Access Compliance Report

Public Rights-of-Way

Intersection ID: 15566	Main Street: HOPEDALE_AV	Cross Street: S_KINGS_DR	Location: SE
ADA ID: 1ACE591AEC8	Ramp Type: PerpDiag	Initial Pass/Fail: Fail	Overall Compliance: No
		Severity Score: 12.5

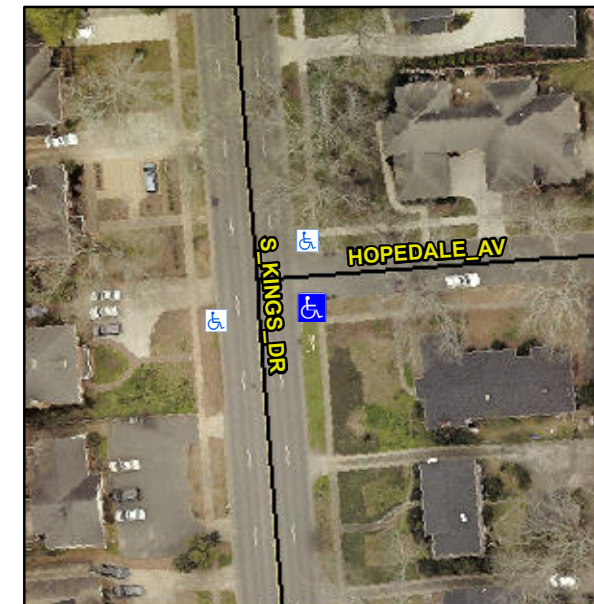
R304.5.3

Compliance	Description	Data	Compliance	Description	Data
N/A	Ramp Length (in)	90.0	Yes	Ramp Slope (%)	7.2
Yes	Ramp Width (in)	48.0	No	Ramp XSlope (%)	5.5
N/A	Flare Type LT	N/A	N/A	Flare Type RT	N/A
N/A	Flare Slope LT (%)	N/A	N/A	Flare Slope RT (%)	N/A
N/A	Flare Traversable LT?	N/A	N/A	Flare Traversable RT?	N/A
N/A	Landing Length (in)	N/A	N/A	DWS Provided?	N/A
N/A	Landing Width (in)	N/A	N/A	DWS Contrast?	N/A
N/A	Landing Slope (%)	N/A	N/A	DWS Length (in)	N/A
N/A	Landing X Slope (%)	N/A	N/A	DWS Full Width?	N/A
N/A	Landing Curb? (Y/N)	N/A	N/A	DWS Offset (in)	N/A
N/A	Shared Landing?	N/A			
N/A	Gutter Ponding?	N/A	N/A	Gutter Slope (%)	N/A
N/A	Gutter Lip Ht (in)	N/A	N/A	Gutter X Slope (%)	N/A
N/A	Painted X Walk1?	No	N/A	Painted X Walk2?	No
	X Walk 1 Direction	To N		X Walk 2 Direction	To W
N/A	X Walk 1 Width (in)	N/A	N/A	X Walk 2 Width (in)	N/A
	X Walk 1 Slope (%)	3.0		X Walk 2 Slope (%)	1.9
	X Walk 1 X Slope (%)	3.3		X Walk 2 X Slope (%)	2.6

Remove & Replace Curb Ramp With Two New Directional Ramps or Equivalent.
